**Chapter 15.80 of the Newport Beach Municipal Code
“Application for an Appeal of decisions, determination or interpretation”**

Address: 7210 W Oceanfront, Newport Beach, CA, 92663

**Plan Check # 2932-2016
Building Permit # X2016-4273**

**Owners Mr. & Mrs. Reeves
Sept 30, 2020**

Exhibit 3

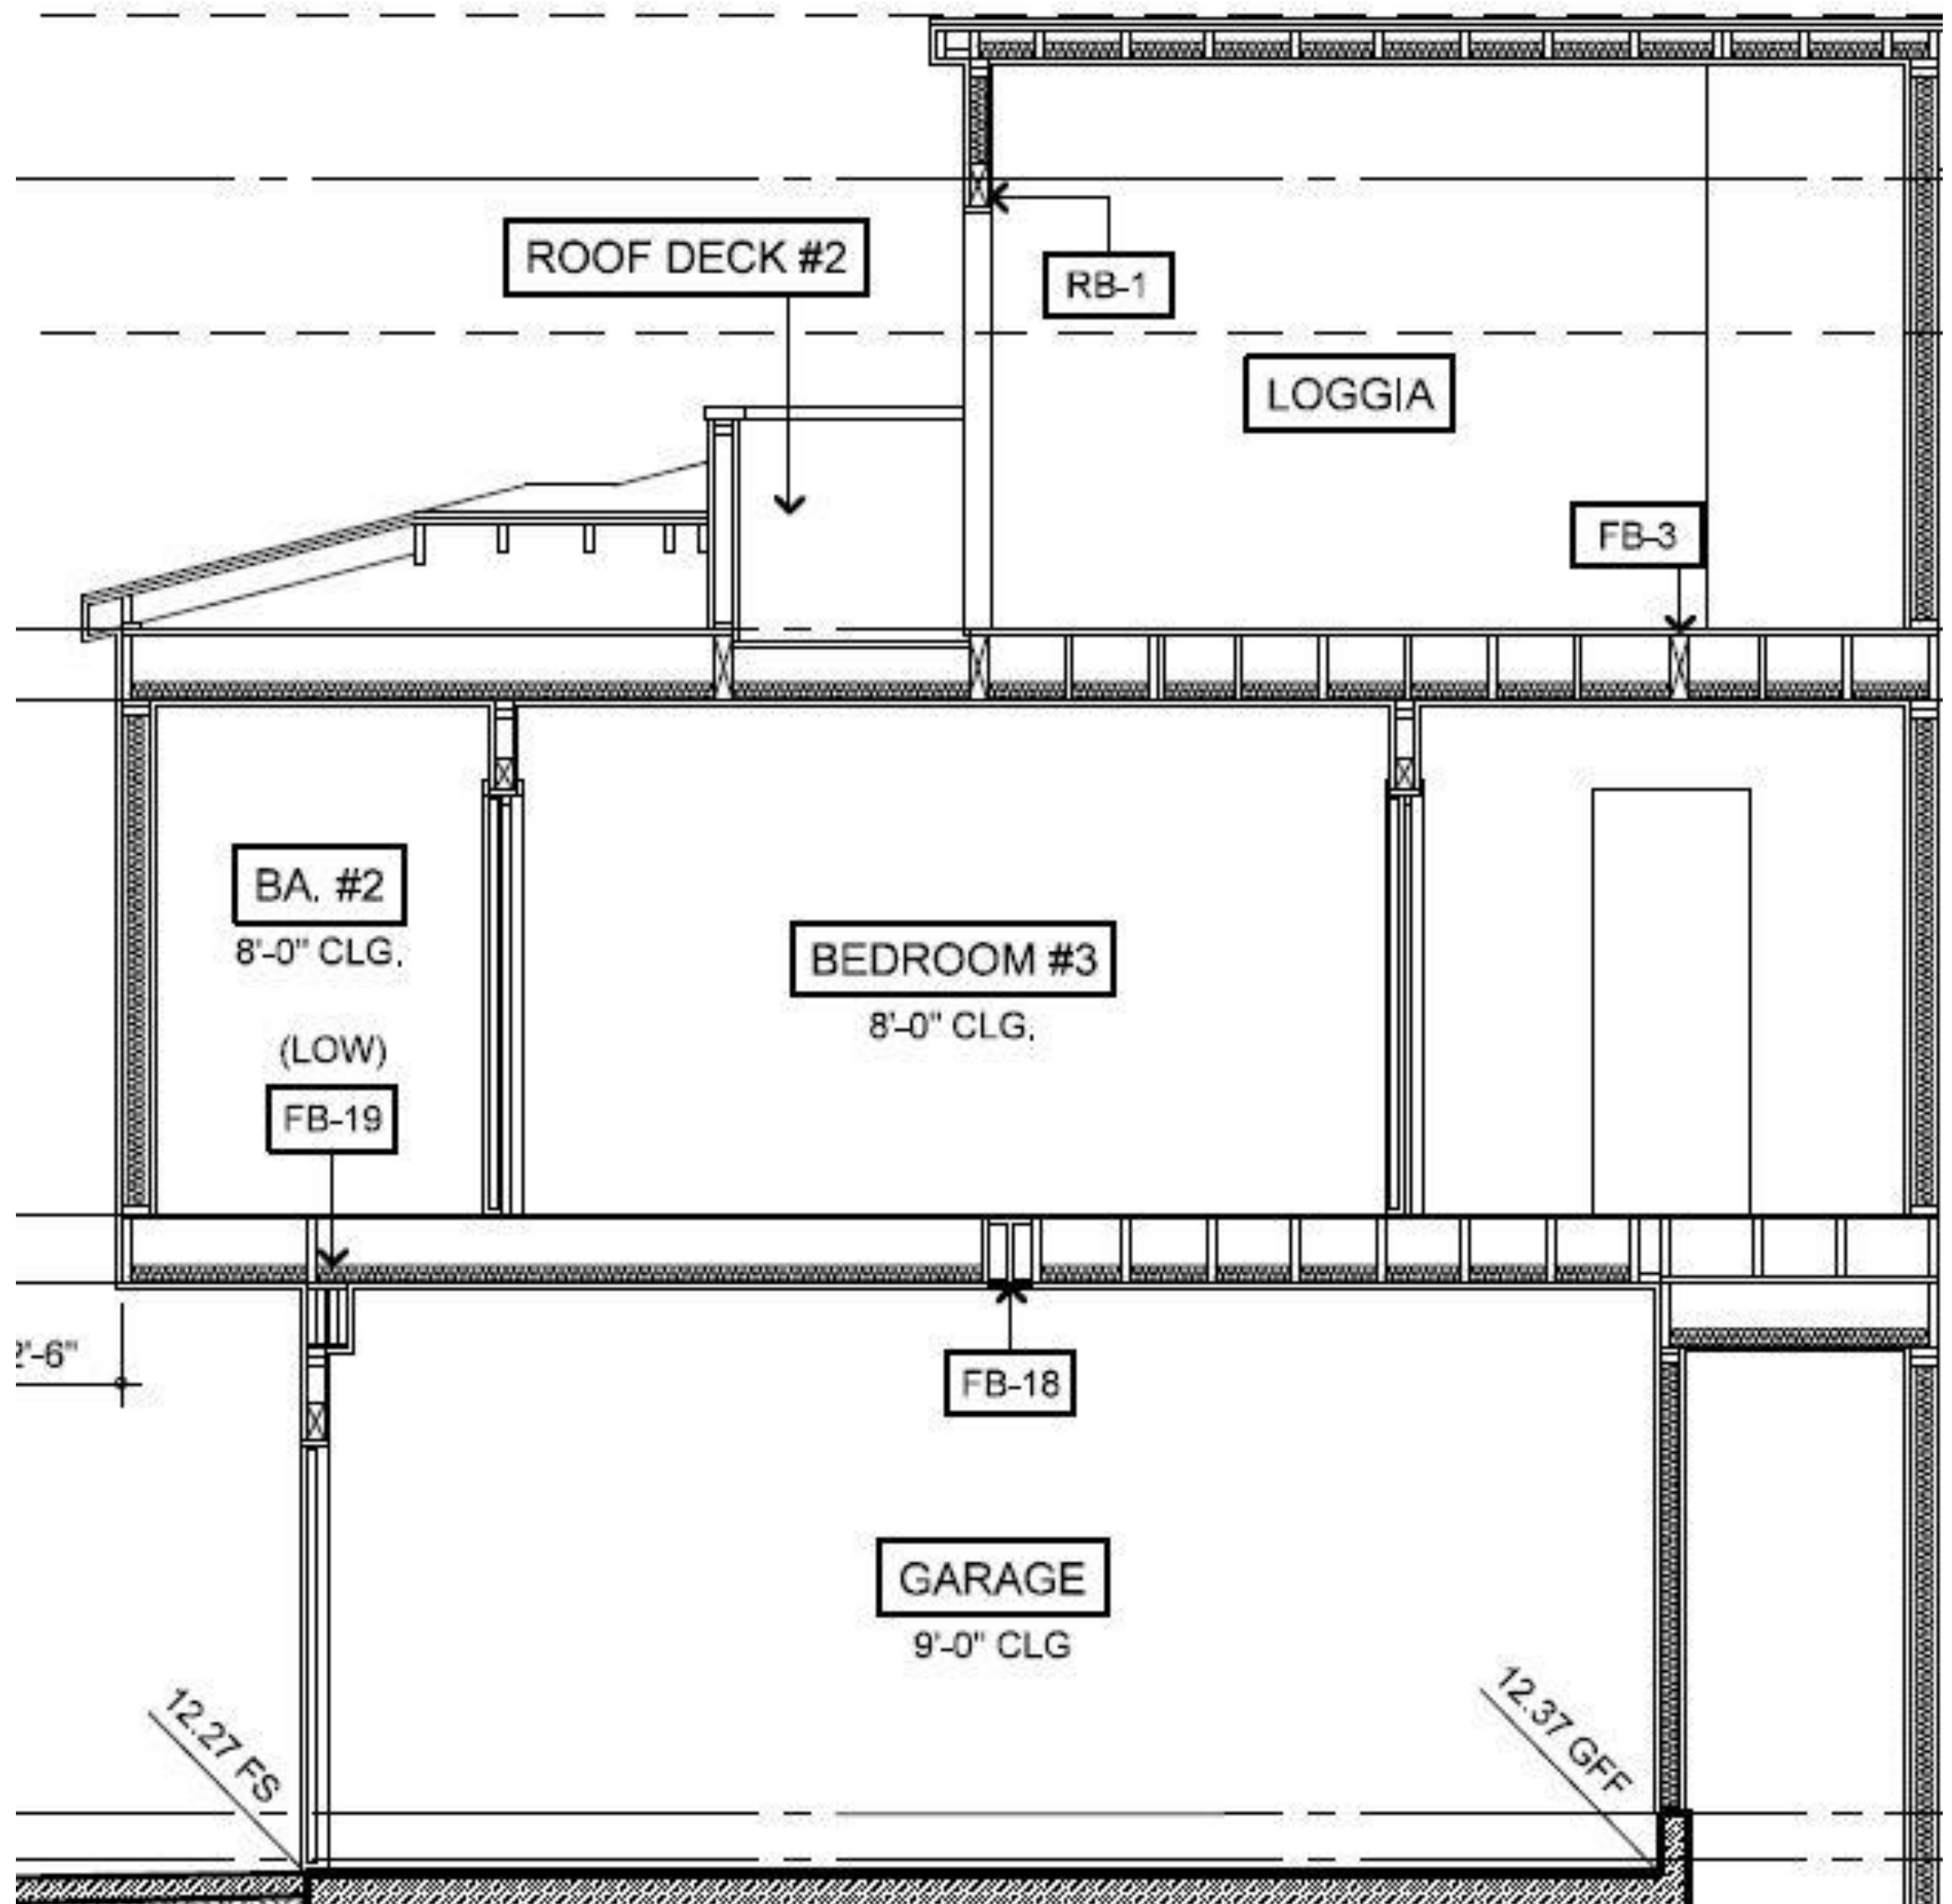
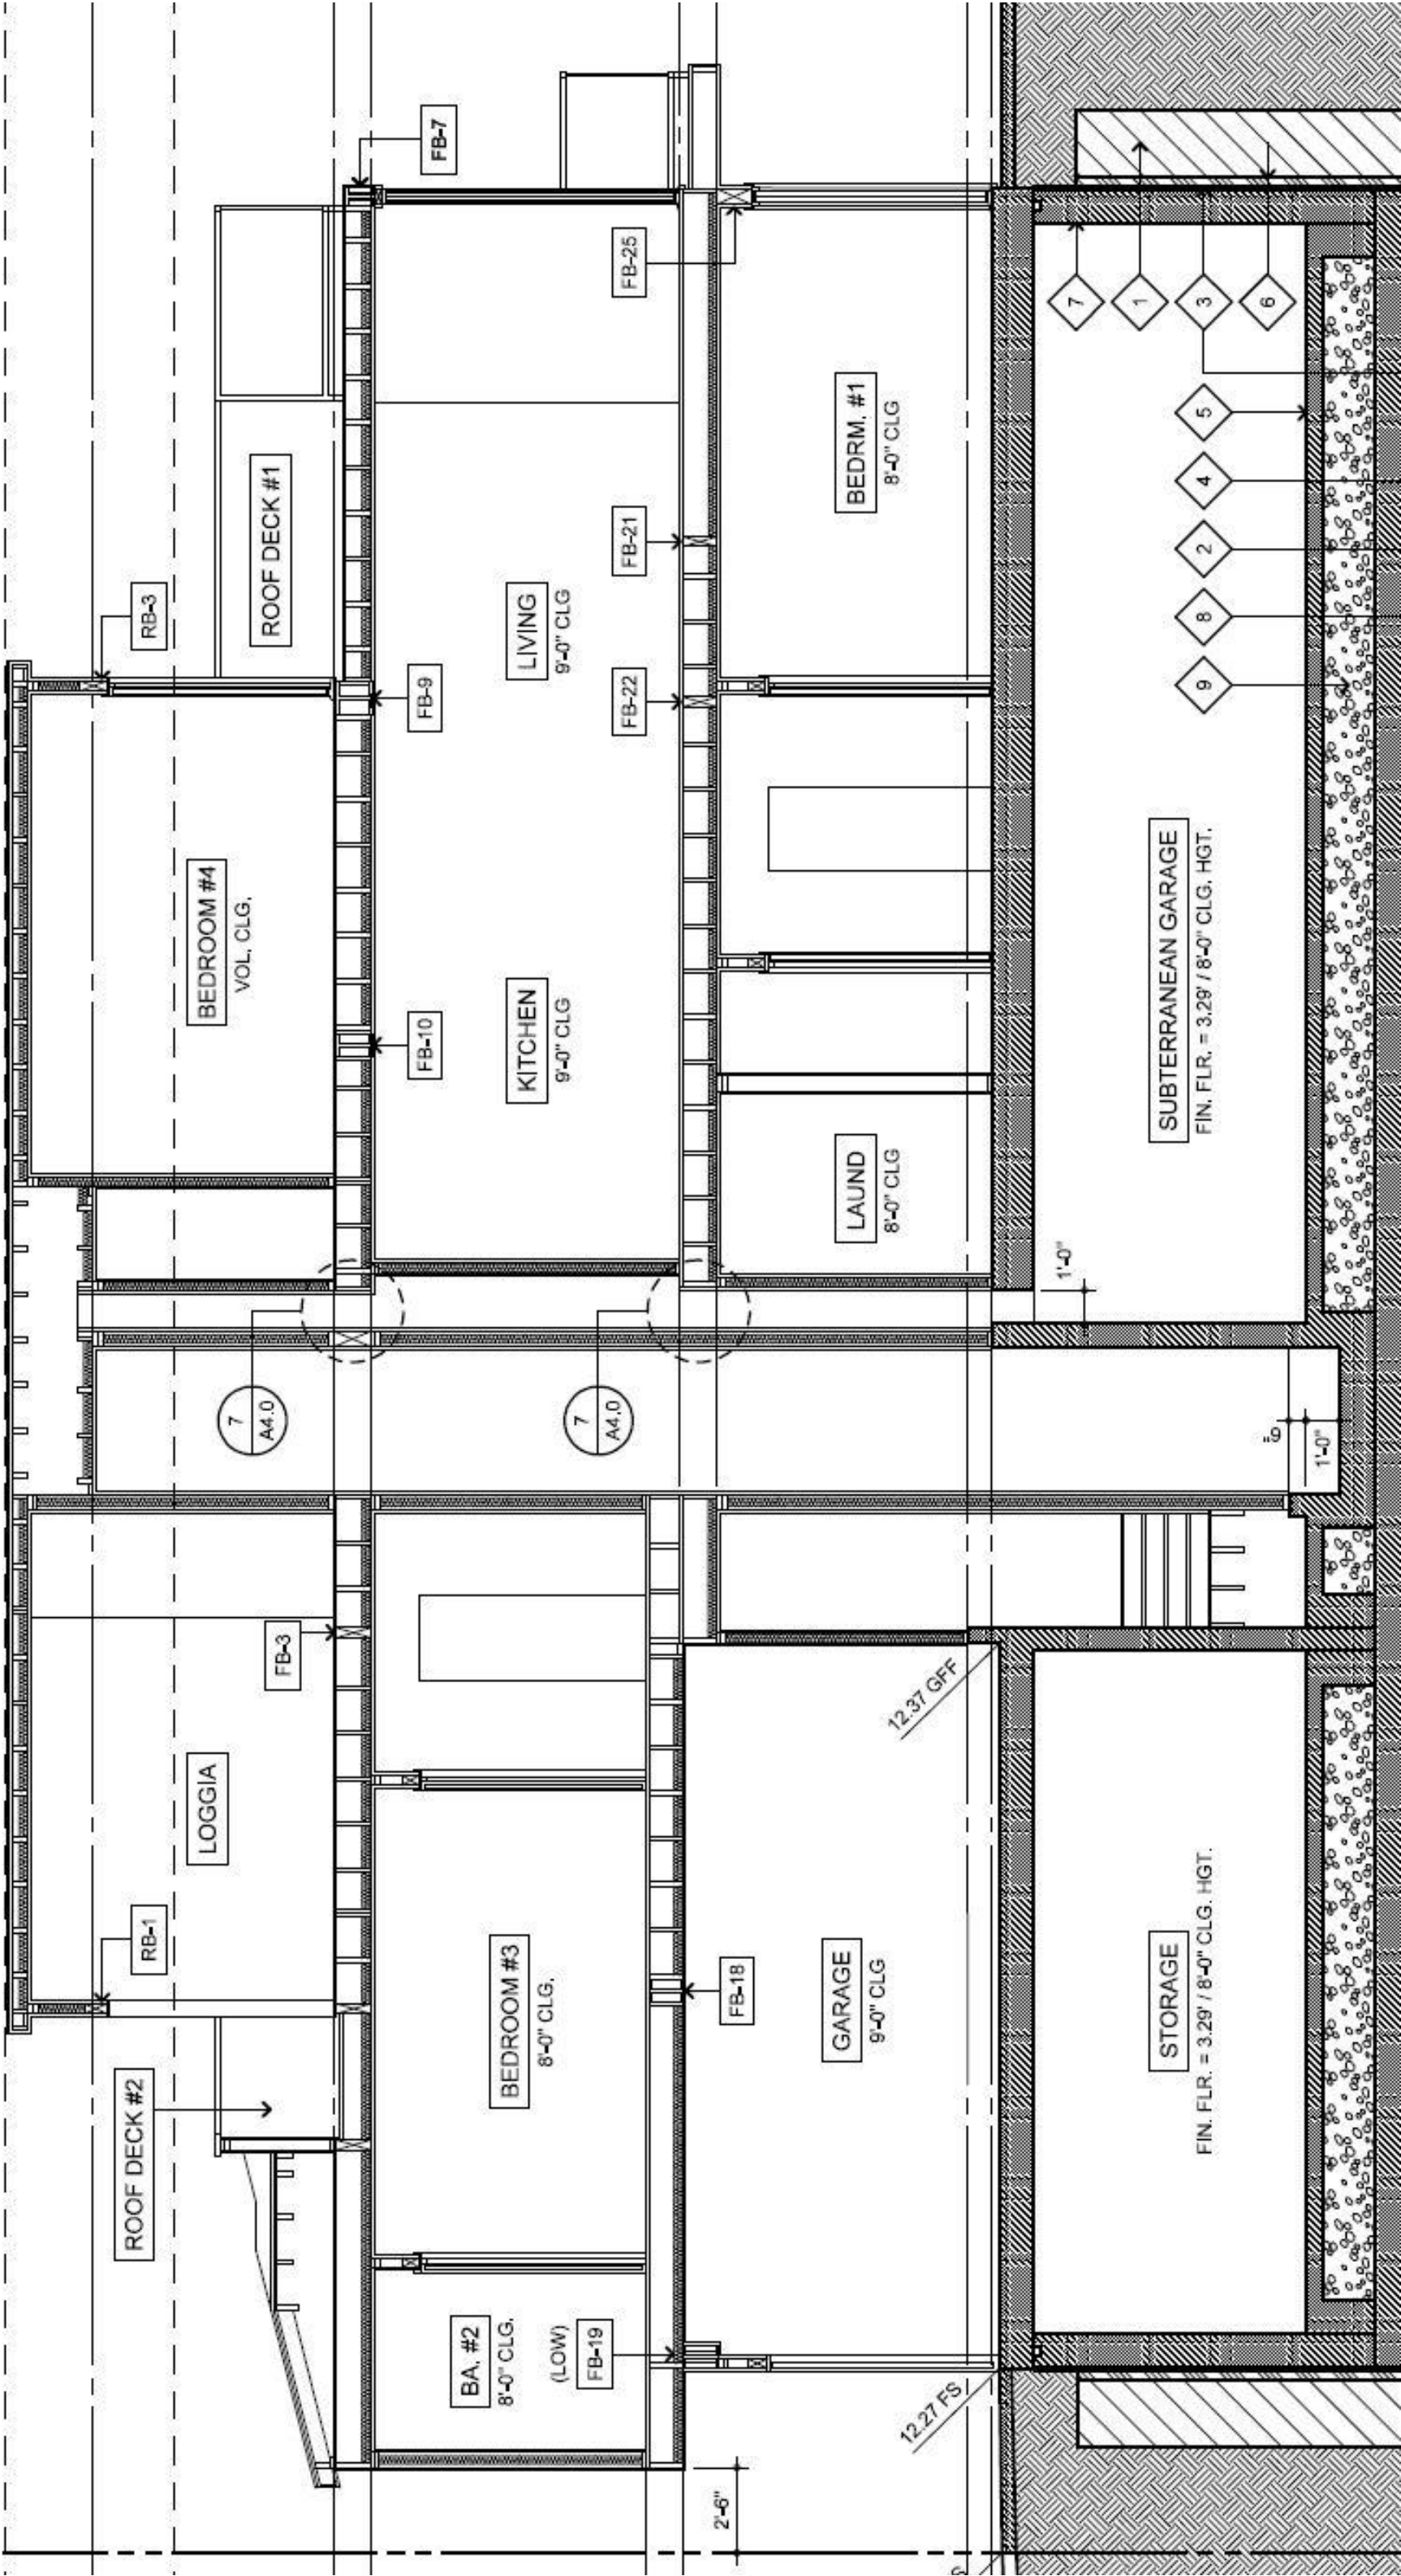
- The approved, building plans do not require or indicate a sloped floor, flashing, waterproofing or “drainage” to be installed in the enclosed third floor Loggia. Furthermore the Threshold (*door track*) is also shown on the approved plans, which now he is requiring the removal of, causing substantial deconstruction and major repairs. (by doing so, would not change anything) (**Exhibit 3**)

Attached please find (**Exhibit 3**), space in question. “3rd Floor Loggia”.
